## DESCRIPTIVE REPORT

*Registry No.*        **H11106**

*General Locality*    **Peril Strait**

### PHB Revisions

Figure 2. H11106 Junction Surveys.

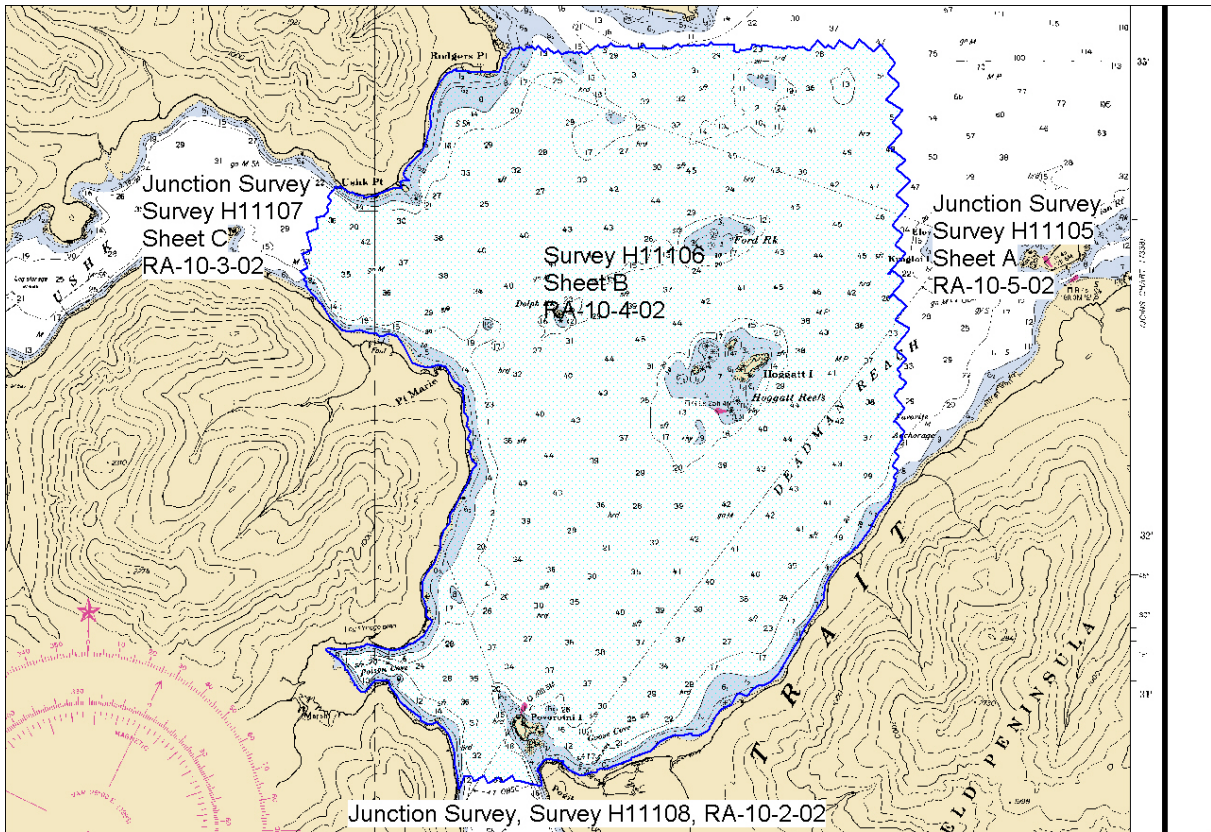
#### Junctions<sup>3</sup>

Survey H11106 junctions well with these surveys, a cursory comparison indicates differences are generally less than one fathom.<sup>4</sup>

<sup>3</sup> The junctions with surveys H11105, H11107, and H11108 are complete. A "Joins" note has been added to the smooth where applicable.
